Commonwealth Edison

Subject: LaSalle County Station Units 1 and 2
Operability Assessment Criteria for
Piping Systems: Supplemental Response
NRC Docket Nos. 50-373 and 50-374

QUESTIONS ON OPERABILITY ASSESSMENT CRITERIA

FLOWCHART

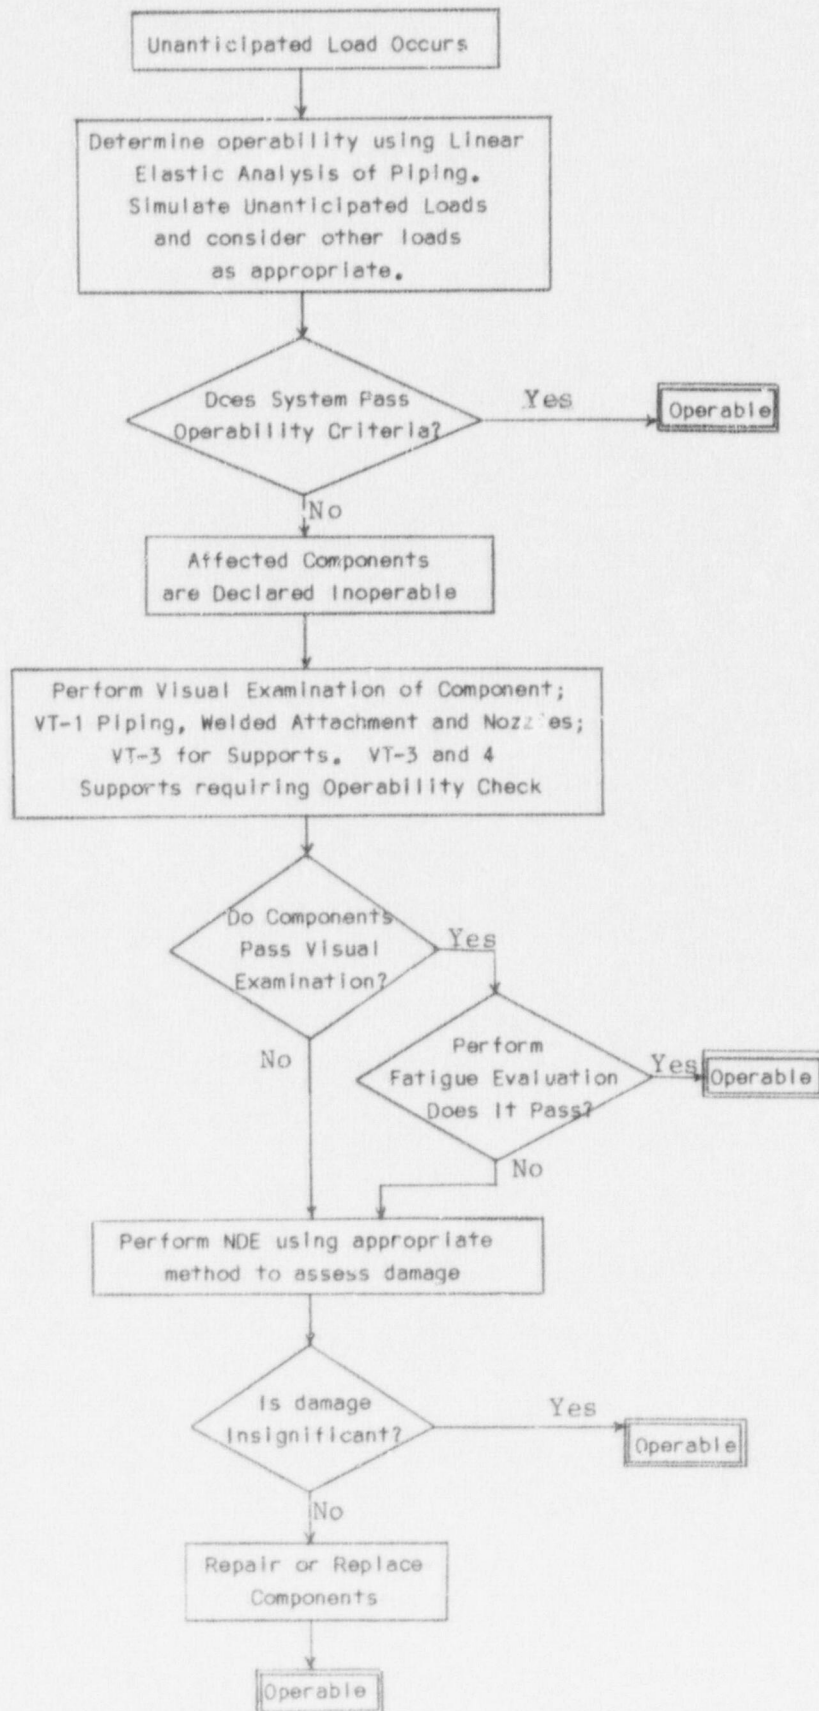
See the attached flow chart for the course of action to be taken after an unanticipated loading. Whether the discovery is made during operation or during an outage, the course of action is the same. If a component does not pass the operability criteria, the component will immediately be declared inoperable and be taken out of service. The component will not be declared operable and returned to service until it passes visual examination or NDE, or the component is repaired or replaced. Corrective actions will be developed on a case-by-case basis after analyzing the source of the unanticipated loading. Examples of corrective actions already implemented included: 1) removing snubbers which were highly susceptible to failure by redesigning the piping support arrangement, and 2) installing new vents on the RHR system where the inability to vent some sections of the system was identified as the problem. Monitoring programs will be considered if the unanticipated load cannot be quickly identified and eliminated.

See flow chart and answer to Question 2.1.

For both mechanical and thermal loads, the procedure is the same. If loads exceed faulted allowables, a visual examination will be performed. Please see the attached flowchart.
